DEVELOPMENT REVIEW BOARD REPORT

39-DR-2005
Raintree Auto Body

Request approval of site plan and elevations for a new 22,780 square foot office and auto body repair building with paint booths.

1
A-1
3

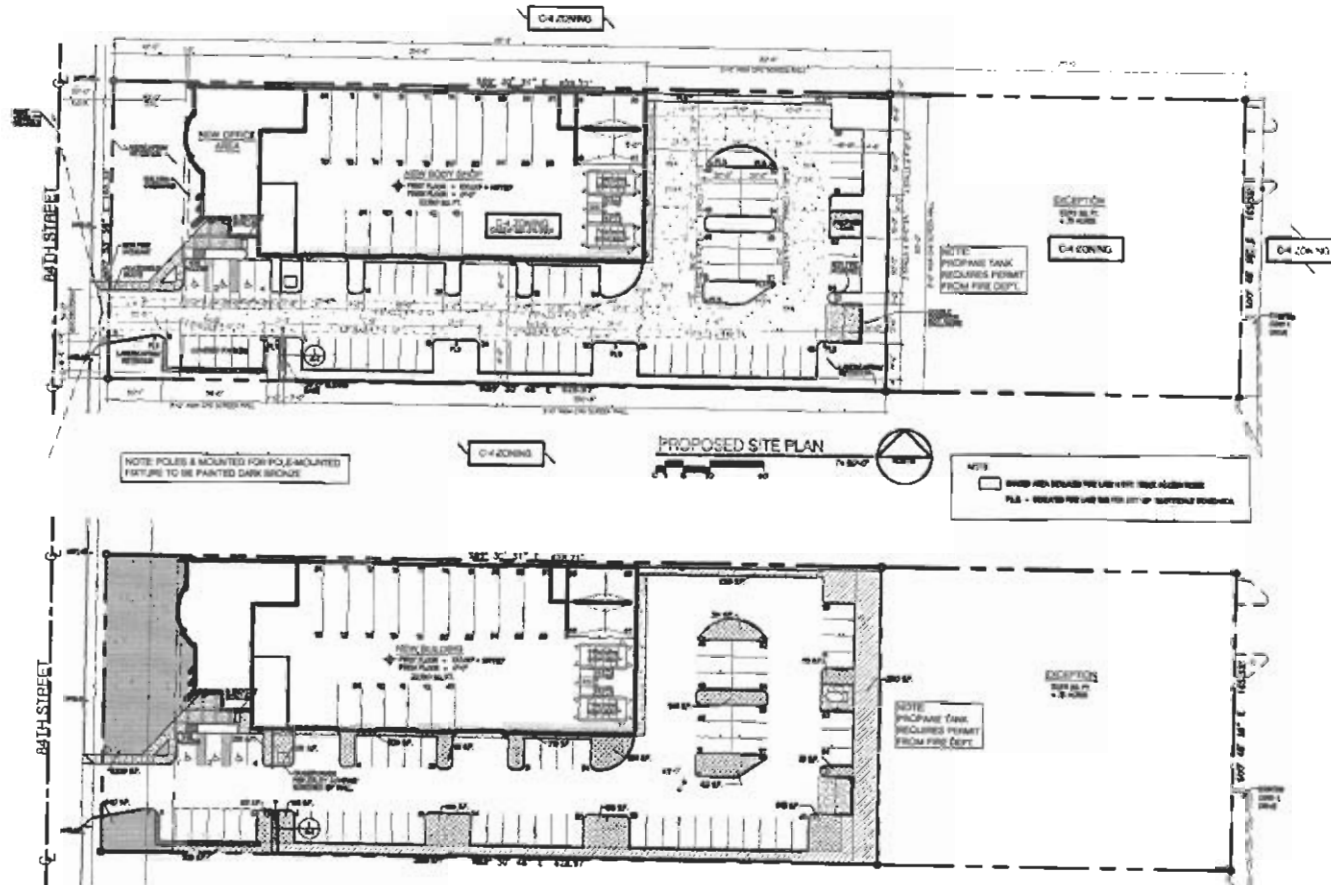
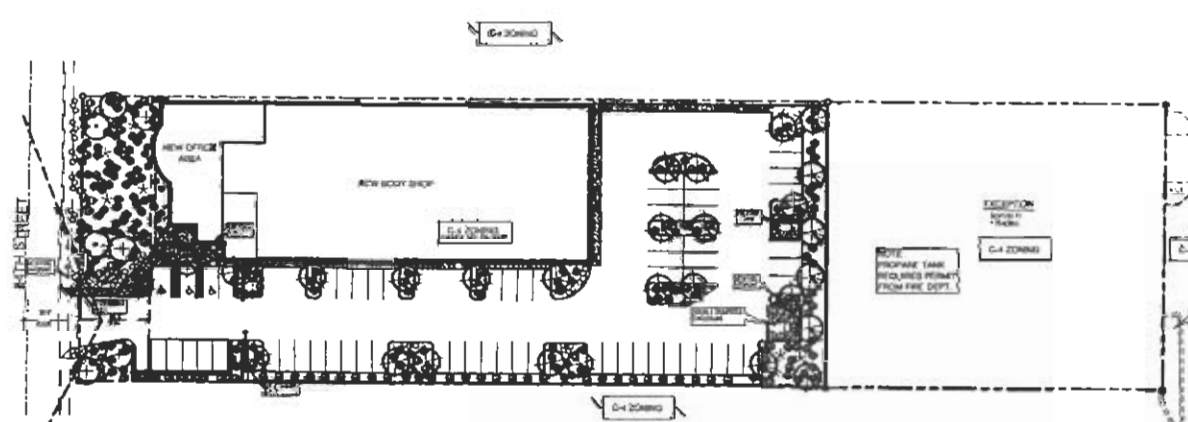
- 25. Preliminary Drainage Statement shows an incorrect volume of stormwater retention required (Vr). Final plans and final drainage report shall show that stormwater storage volume provided is greater than the volume required (Vr) of 15,110 cubic feet.
